UNITED STATES PATENT AND TRADEMARK OFFICE

10/039,942

SEMENENKO, YURIY

DETAILED ACTION

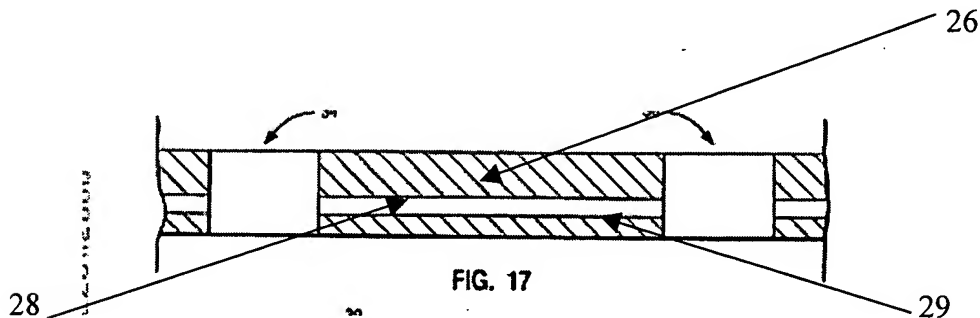
Frankeny teaches the device comprises an external copper layers 26 and 29 (see below, Fig. 17). At time the invention was made, it was well known to use copper as external layer for printed wiring board (PWB).
